## **Regional Municipality of Durham**

### **Bid Opportunity: T-1160-2021 – Construction of New Seaton Paramedic Station and Training Facility in the City of Pickering**

#### **Addendum Number 02 – December 3, 2021**

M-101: Partial Floor Plan - Drainage

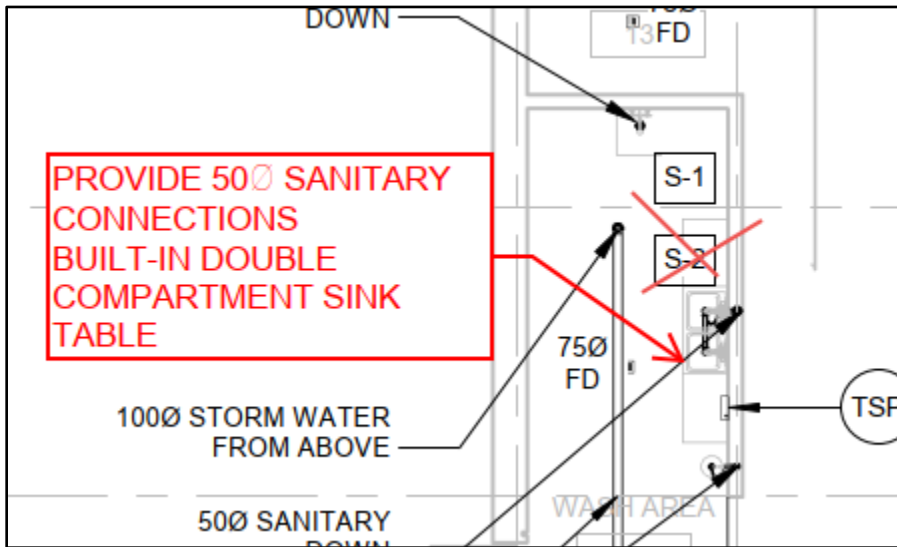
Regarding stainless steel can you please clarify the following: Where is all the Stainless Steel Casework shown on the drawings (Specification section 12 31 00), is there a detail on cabinet height, width, depth? (drawer or shelf details are important as well)

Please provide scullery sink RFDS-96-2B by Interdyne Systems Inc., or approved equal. Holes for plumbing to be coordinated with supplier during Submittals. See Partial Plan revisions below.

Addition of a Stainless-steel countertop cut sheet appended to Section 22 42 00 Plumbing Fixtures and attached to this Addendum 02.
